## Planning Commission Staff Report

<b>Project type:</b>	Amended Architectural Elevations
<b>Meeting Date:</b>	February 12, 2024
<b>From:</b>	Shilpi Bharti, Planner <i>SB</i>
<b>Location:</b>	900 Spirit of St. Louis
<b>Description:</b>	<b>Gateway Studios, Lot 1A:</b> Amended Architectural Elevations for a 19.3-acre tract of land zoned “PC” Planned Commercial District located on the north side of Chesterfield Airport Road and east of Spirit of St. Louis Boulevard.

RE: Spirit of St. Louis Corporate Center (Gateway Studios) Lot 1  
900 Spirit of St. Louis Blvd., Chesterfield, MO  
**ARB Comments - Main Building**  
GMA Job No. SJ2324

Figure 4: Replaced Curtain wall on west

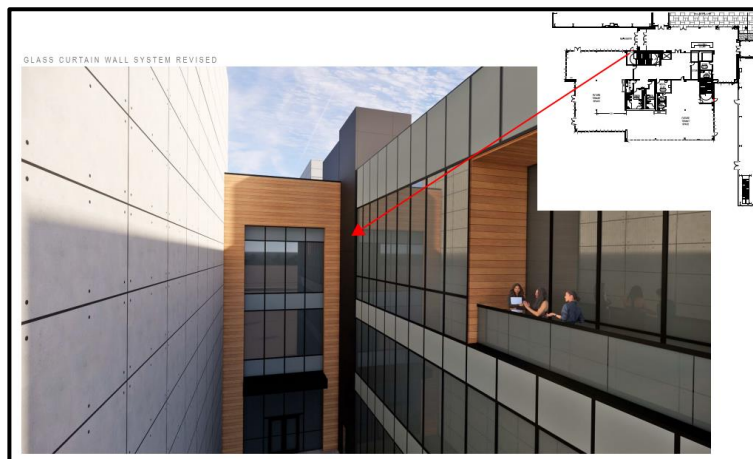
Additionally, the applicant is proposing to replace some portion of the curtain walls on the west and south interior walls with ACM paneling which is similar to the roof deck area as shown in figure 4 and 5.

Figure 6: Proposed West Side Elevation

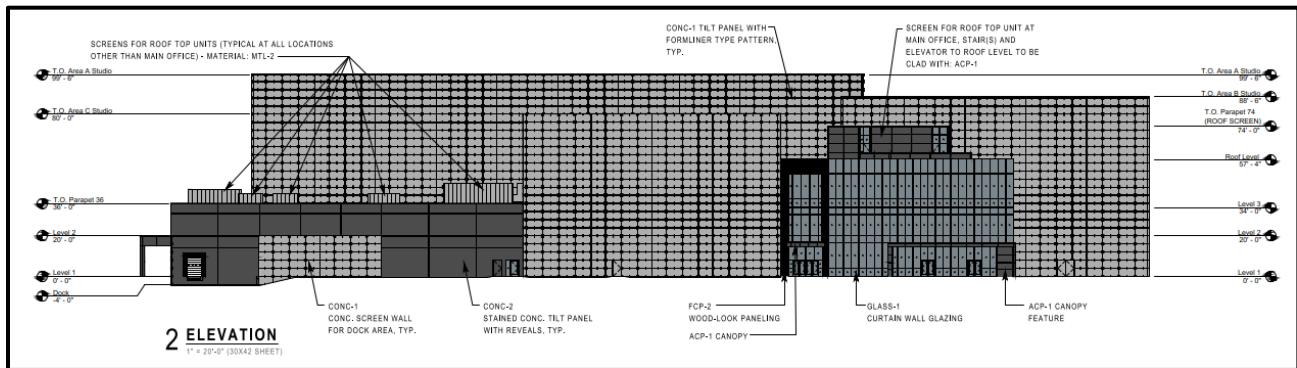
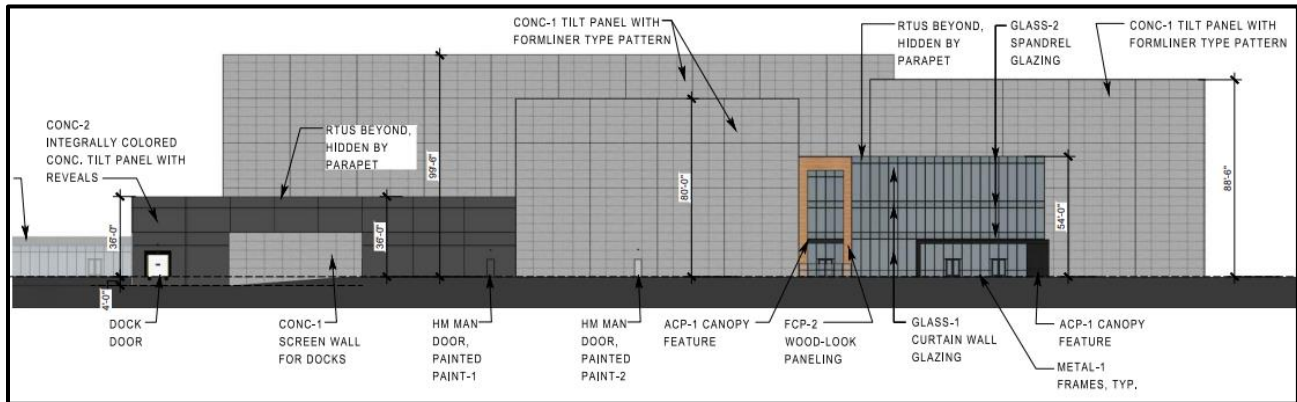
The studio and the office portions of the campus are under construction. The applicant has is proposing additional rooftop mechanical equipment screening walls on the building. The tallest screening will be 17' high and will be visible from the west and north sides of the building.

The screen for the roof top unit at the main office, stairs, and elevator to roof level will be clad with Dusty Charcoal color aluminum composite metal paneling. Proposed mechanical equipment roof top screening will be flat, pre-finished metal panel with joints aligned to correspond with the concrete wall panels, except the main building screening. The screen for the roof top unit at the main office, stairs, and elevator to roof level will be clad with Dusty Charcoal color aluminum composite metal paneling.

Figure 9: Isometric view showing mechanical equipment screening

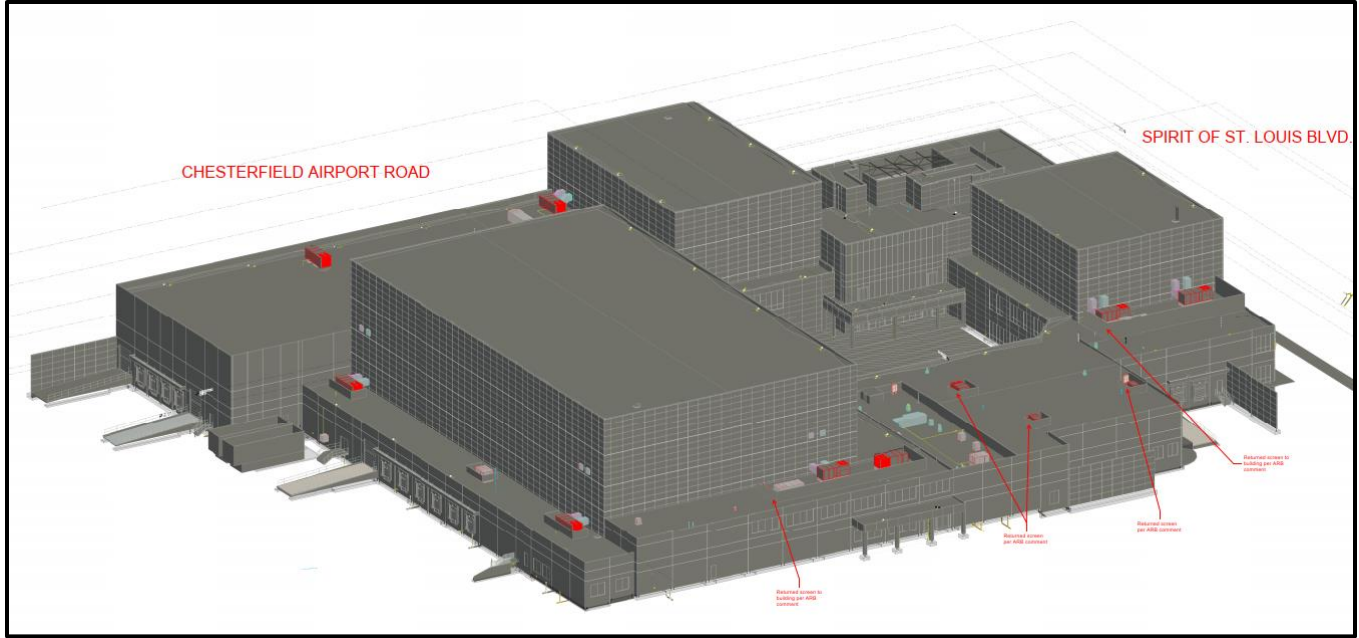
1. Color of wall infill panels where duct penetrations were omitted shall match adjoining wall surfaces as closely as possible.
2. Metal screening panels at roof top mechanical units shall be extended around corners to provide more effective visual obstruction.
3. Generator color shall be compatible with colors of adjacent building materials.

**ITEM 2: Metal screening panels at rooftop mechanical units shall be extended around corners to provide more effective visual obstruction.**

- *Please see the first attachment for modifications to the roof screen to address the ARB's comment.*

SIGHT LINE - INT. OF CHESTERFIELD AIRPORT ROAD and EAST INTERIOR ROAD

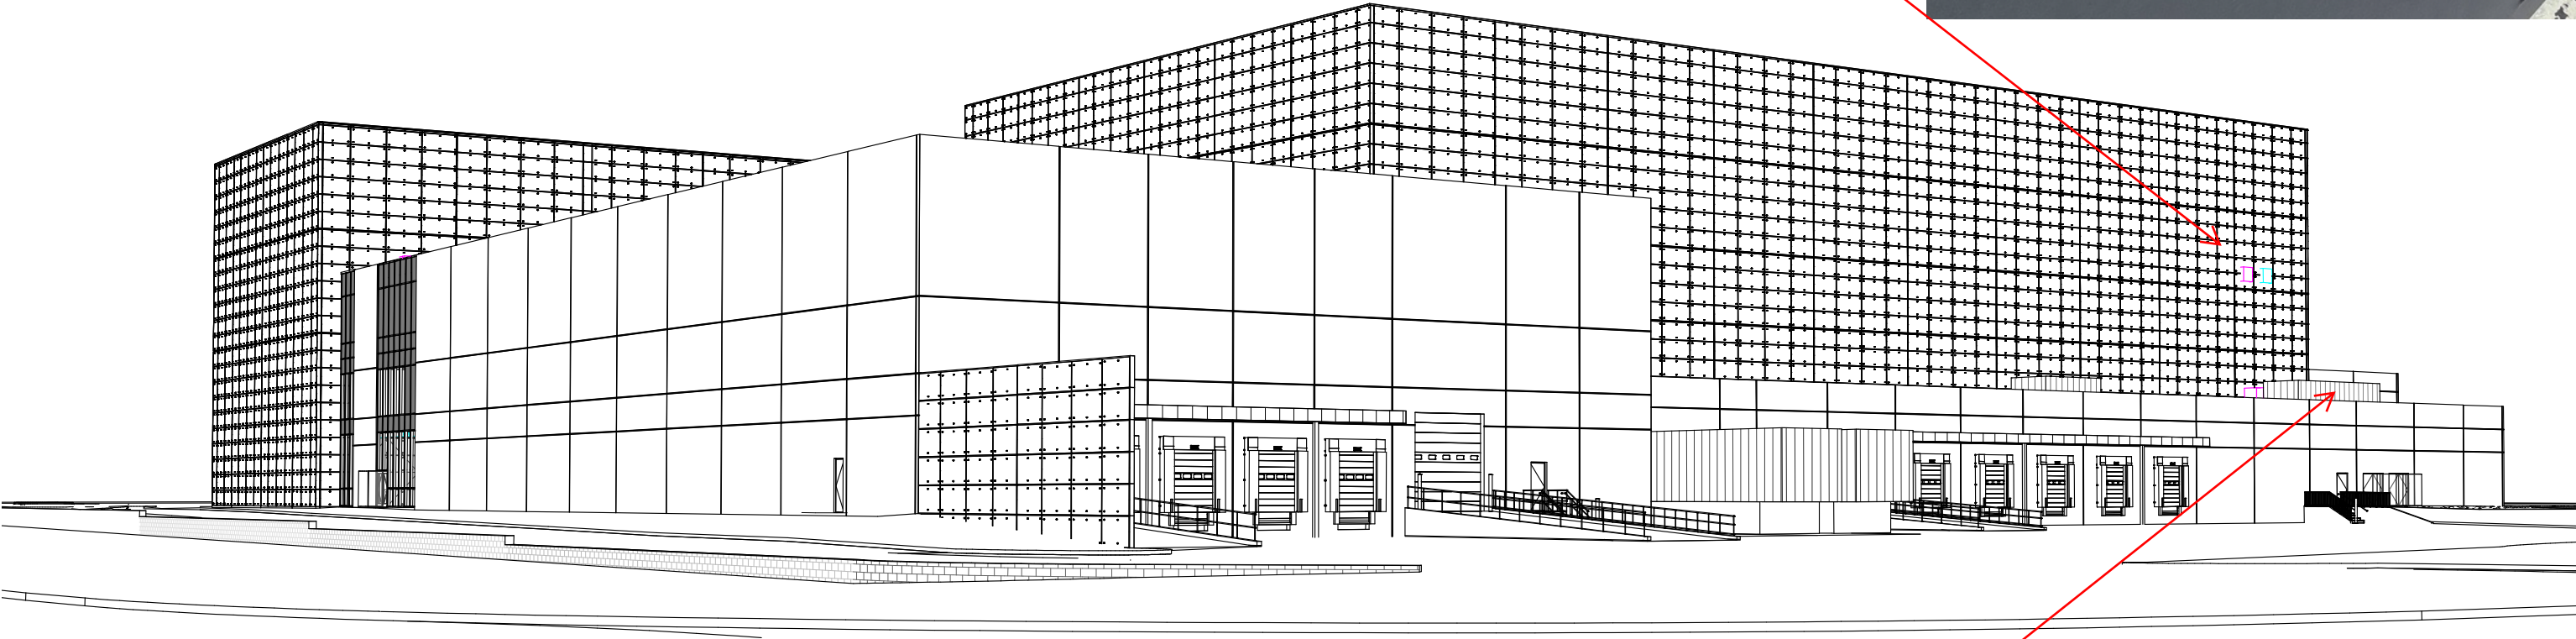
**ITEM 1: Color of wall infill panels where duct penetrations were omitted shall match adjoining wall surfaces as closely as possible.**

EXPOSED DUCTWORK WILL ENTER THE BUILDING DOWN LOW AT ROOFTOP UNIT HEIGHT. EXISTING HOLE WILL BE PATCHED TO MATCH CONC.

ROOF SCREEN MATERIAL HAS BEEN CHANGED TO A FLAT PANEL WITH VERTICAL JOINTS TO MATCH SIMILAR METAL PANELS ON THE BUILDING

ALL CONC. WALLS (EXCLUDING THE TALL STUDIO WALLS AND SCREEN WALLS WITH THE FORMLINER) TO BE STAINED BLACK (ONYX) AS DEFINED ON THE ORIGINAL COLOR ELEVATIONS. SEE ATTACHED INSET FOR A SAMPLE OF THIS STAIN.

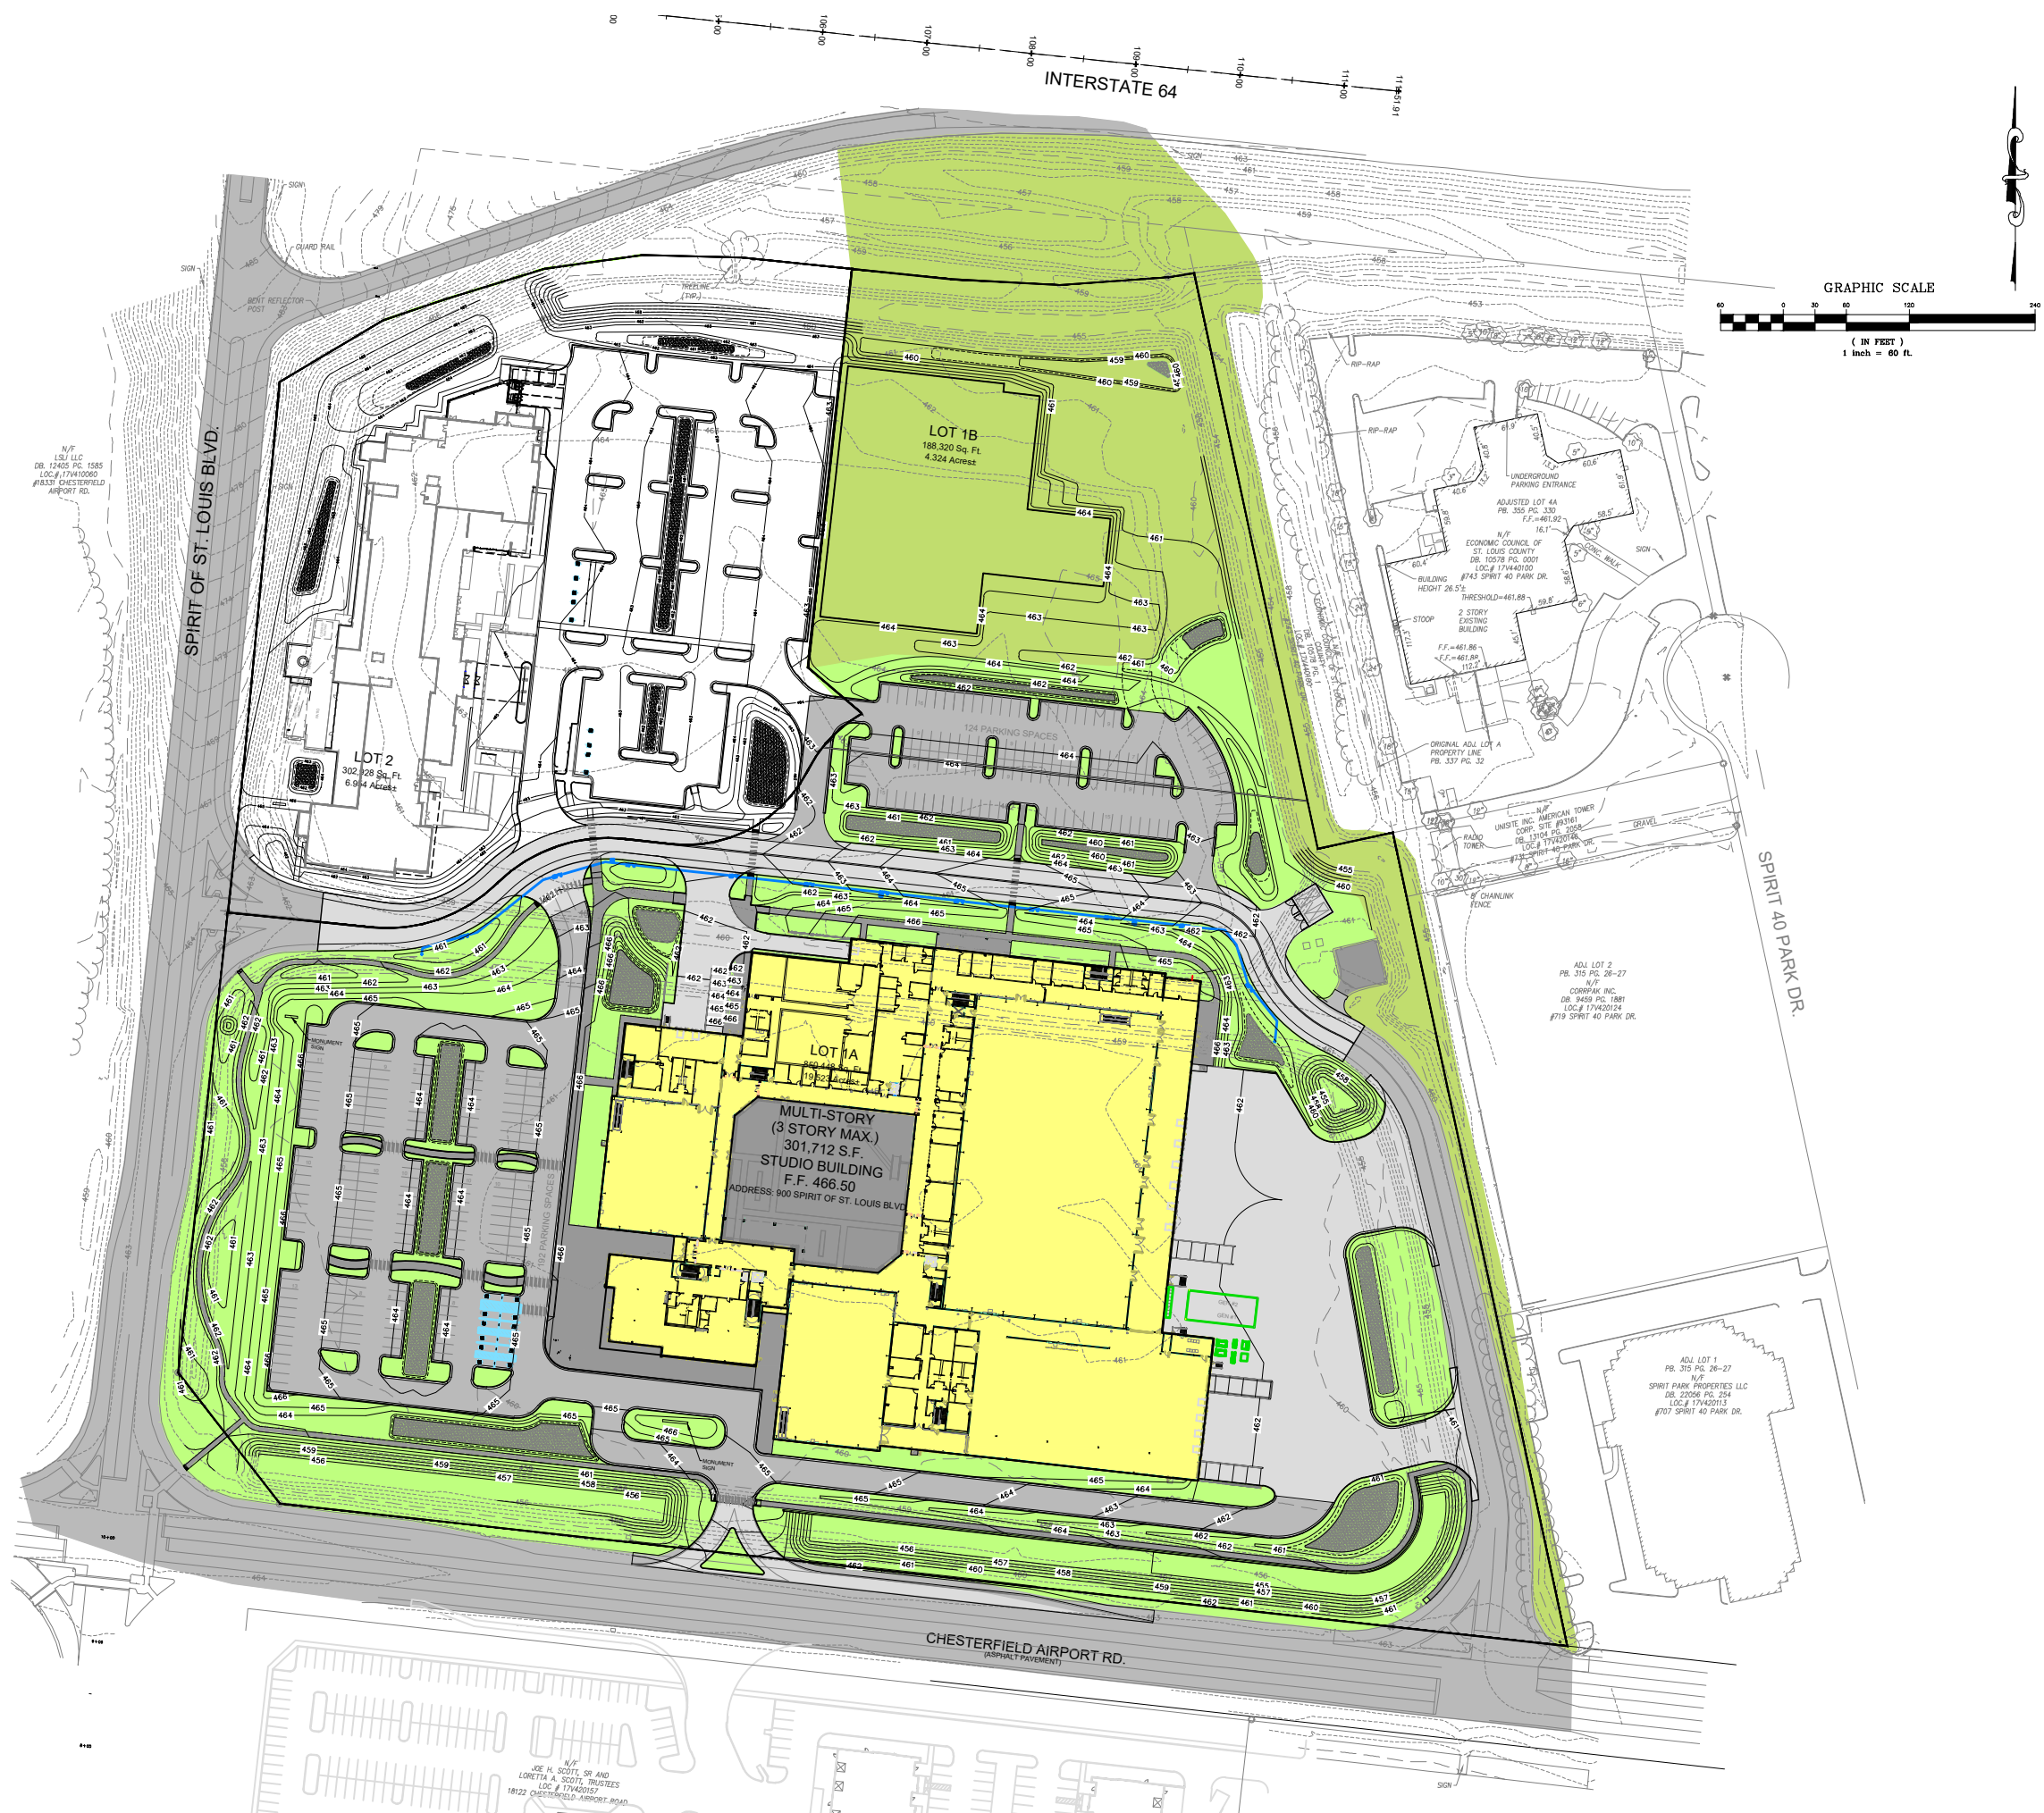
**ITEM 3: Generator color shall be compatible with colors of adjacent building materials.**

- *Please see the second attachment for the generator color that was selected. This color was chosen to be compatible with the colors of the adjacent building materials.*
